COUNCIL ASSESSMENT REPORT

Panel Reference	PPSSCC-243
DA Number	DA 688/2019/JP/A
LGA	The Hill Shire Council
Proposed Development	Section 4.55 (2) Modification to an Approved Residential Flat Building Development comprising 296 units.
Street Address	3-9 Fishburn Cr. & 14-16 Middleton Av. and 37-45 Dawes Av. Castle Hill
Applicant	Bridgestone Projects
Consultant/s	Town Planner: Willow Tree Planning Architect: PTW Architects Fire Engineering and BASIX: Stantec Australia Quantity Surveyor: Westbourne Constructions
Date of DA lodgement	03 December 2020
Number of Submissions	Nil
Recommendation	Approval subject to conditions
Regional Development Criteria (Schedule 7 of the SEPP (State and Regional Development) 2011	Section 4.55(2) to an application previously approved by the panel and subject to a departure from development standards set out in Schedule 1
List of all relevant s4.15(1)(a) matters	<p>EPIs:</p> <ul style="list-style-type: none"> • State Environmental Planning Policy (State and Regional Development 2011) • State Environmental Planning Policy No. 55 – Remediation of Land • State Environmental Planning Policy No 64 – Advertising and Signage • State Environmental Planning Policy

Figure 1: Section A – Proposed Modification (Buildings A, D and C)

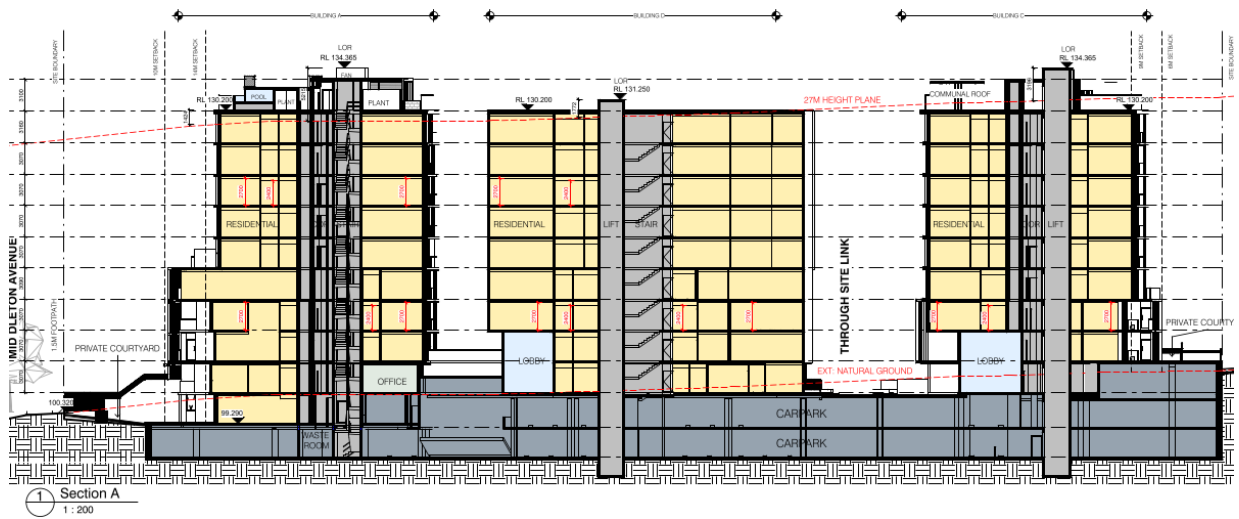
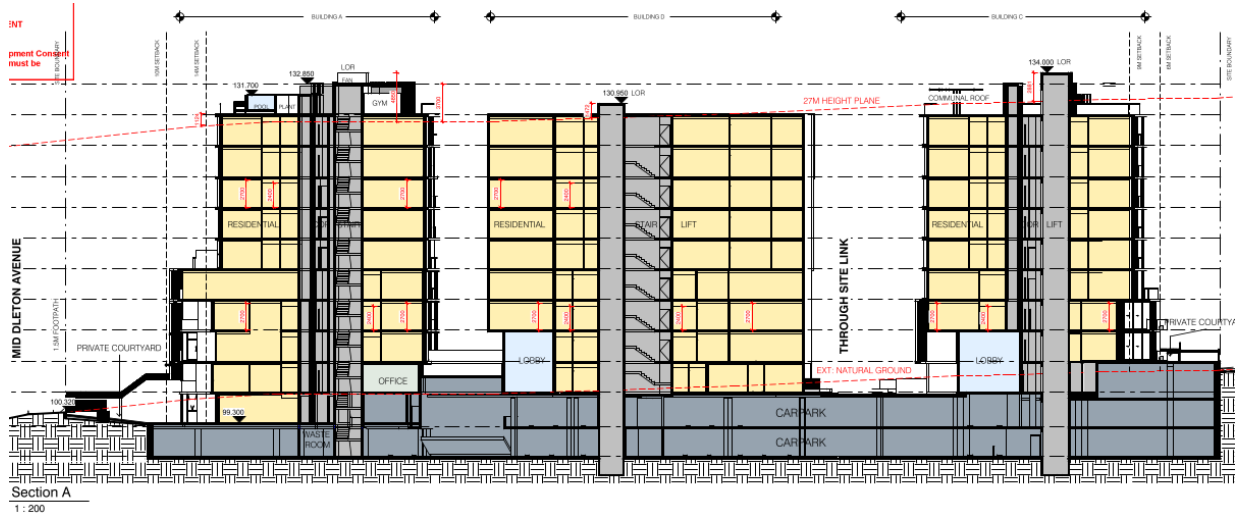
This modification primarily relates to a minor increase in overall height of up to 365mm to allow for sufficient area for insulation services. This is a 1.38% increase from the approved development. A comparison of the proposed development and approved development is detailed in the below sections (refer Figures 1 – 4). The comparison demonstrates that there are negligible changes in built form subject to the height exceedance.

Figure 5: Columns proposed as part of subject application as reviewed by DRP

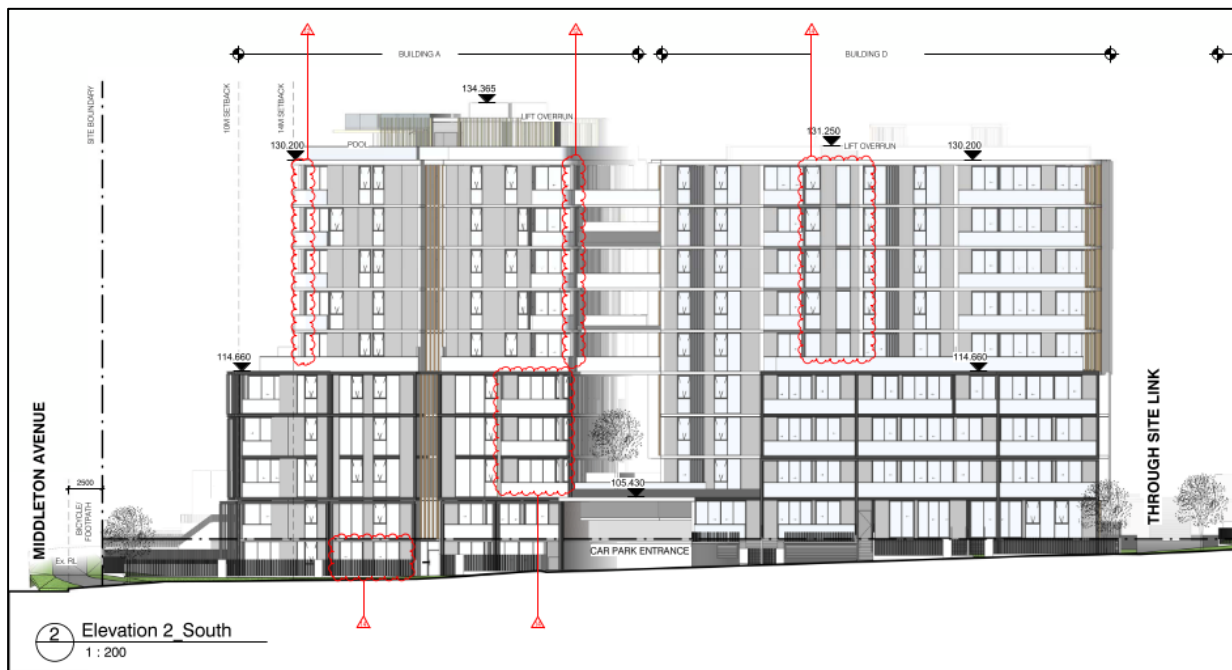
- Columns have been added to a number of corner balconies due to structural transfer requirements and building height limitations. To ensure better visual integration to the columns within the façade, the columns have been treated with a timber look screening similar to other elements within the approved façade design (refer figure 6). In addition, existing blade wall elements have been extended to enable some of the circular columns to be removed, providing a design which is more consistent with the approved development.

Figure 6: Columns wrapped with timber look screen as a response to DRP concerns.

Figure 8: Proposed balcony extension to Unit G26

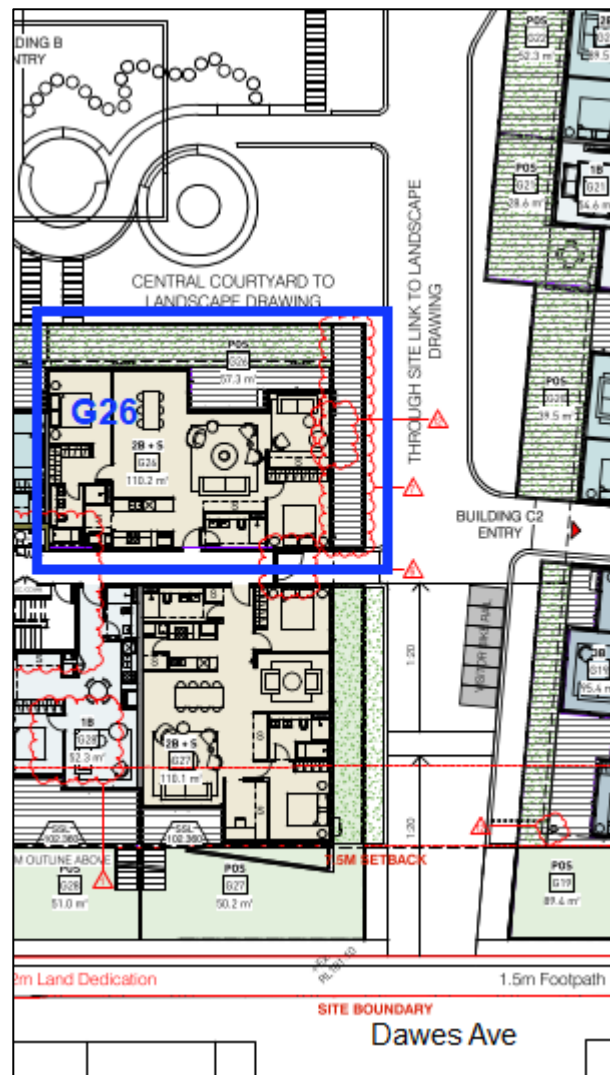
The proposed modification includes an extension to the impervious ground floor private open space area of Unit G26 from 39.9m² to 57.3m². Refer figure 7 and 8 below. The terrace extension would result in the deletion of two *angophora floribunda* Rough barked apple medium canopy trees and three *cyathea cooperi* Australian tree ferns as detailed in the approved landscape plans. Further, the proposal would result in Unit G26 comprising a 1m setback to the public pedestrian cross through link which would be insufficient space to plant medium canopy trees. No amended landscaping plans have been provided to address the public and private interface. It is considered that compared to the approved 3m building setback to the public cross through link, the proposal would result in detrimental landscaping and visual amenity impacts for future occupants in Unit G26.

In this regard, no further variation to the site coverage control is supported. A condition is recommended to delete the extension of the balcony in Unit G26 and landscaping to be provided as originally approved. Refer condition 1.

- The balcony extension to the east of Unit G26 is not supported and is to be deleted from the plans. Trees are to be planted in accordance with the approved Landscape Design Report.
- To ensure overlooking impacts are minimised, privacy louvres or obscured glazing is to be installed to the east facing windows of Unit G26.
- The room to the north of the kitchen in Unit G01 is only to be used for storage purposes.
